30" SQUARE CFRP & SS PRESTRESSED
CONCRETE PILE

INDEX
455-130

Proposed Revisions to a Standard Plans Index
(Please provide all information — Incomplete forms will be returned)

Index Number: 455-130

STRAND PATTERN

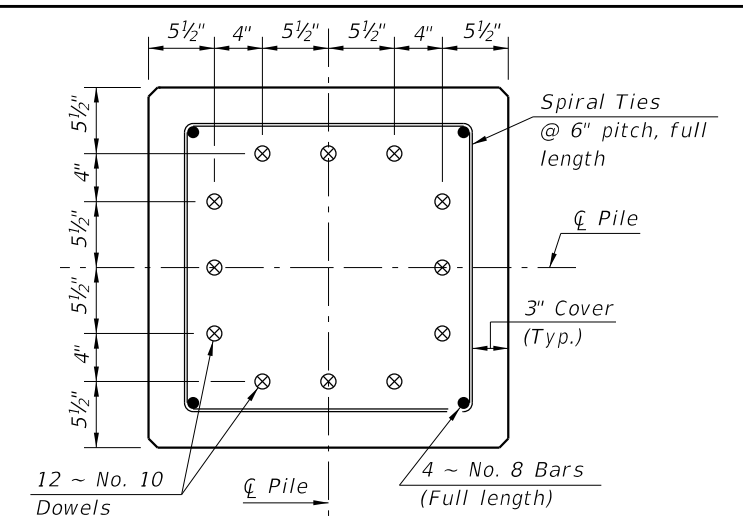
Added 0.6" HSSS strand

32 ~ 1/2" Ø, HSSS at 26 kips

24 ~ 0.6" Ø HSSS at 35 kips
